ENGINEERING TEST OF MEAL, UNCOOKED, 25-MAN

SUBJECT: Approved Final Report of Engineering Test of Meal Uncooked,
25-Man, USATECOM Project No. 7-3-0171-02

**Final Report of
Engineering Test of Meal, Uncooked, 25-Man**

Figure 2. Typical Recipe and Menu Information and Schedule Sheet for Meal, Uncooked, 25-Man.

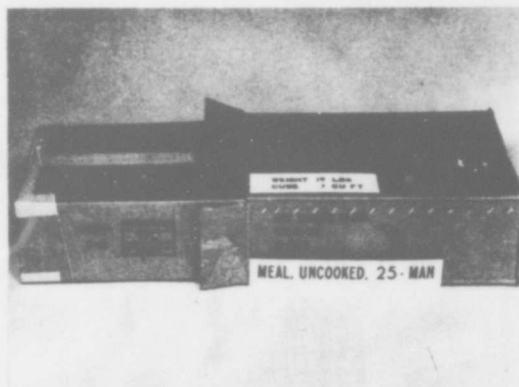
(1) The suggested preparation time schedule, shown in the Menu Information and Schedule Sheet, was not realistic and was misleading (Par. 2.3.4 and Table III).

The time schedule as shown in the Menu Information and Schedule Sheet (Fig. 2), although a suggested schedule, is not realistic and is misleading to the user. Since the preparation time schedule can be affected by many conditions, some of which are uncontrollable, it is recommended that the time schedule be eliminated from the Menu Information and Schedule Sheet. The Unit Mess Steward would then establish a time schedule based on the specific preparation time for specific items, as shown in the recipe attached to each component package (unit package label - Fig. 2), the number of modules to be prepared, environmental conditions, and related factors.

2.1 Preparation time schedule shown in the Menu Information and Schedule Sheet, although a suggested schedule, is not realistic and is misleading to the user (Par. 2.3.4 and Table III).

Delete time schedule from the Menu Information and Schedule Sheet, and leave the overall preparation time to the judgment of the user based on the recipes, number of modules to be prepared, environmental conditions, and related factors.
